Summary of Agency and Tribal Feedback for Jeffers Petroglyphs Site and Red Rock Ridge

Jeffers Petroglyphs and Red Rock Ridge

Big Bend Wind Project – Summary of Feedback

This is a living document which is updated frequently to provide additional detail and recent feedback. This version is current as of September 29th, 2020.

Incorporating Feedback: Revising Project Boundary

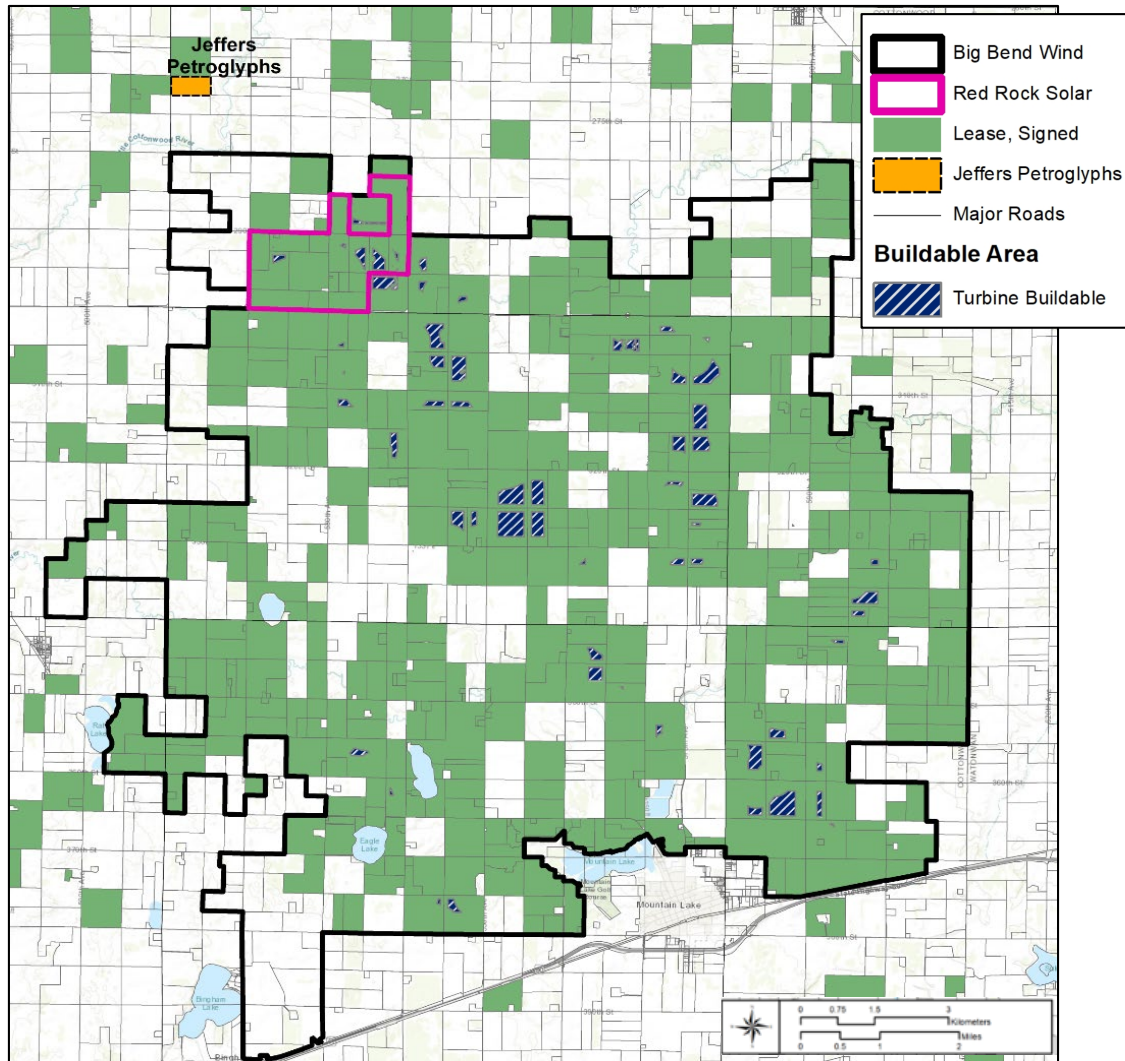
- Boundary has been revised to avoid Jeffers Petroglyphs
- Current project area is >0.5 miles from Jeffers Petroglyph site
- As currently planned, the nearest turbine will be 2.3 mi from SE corner of Jeffers Petroglyphs
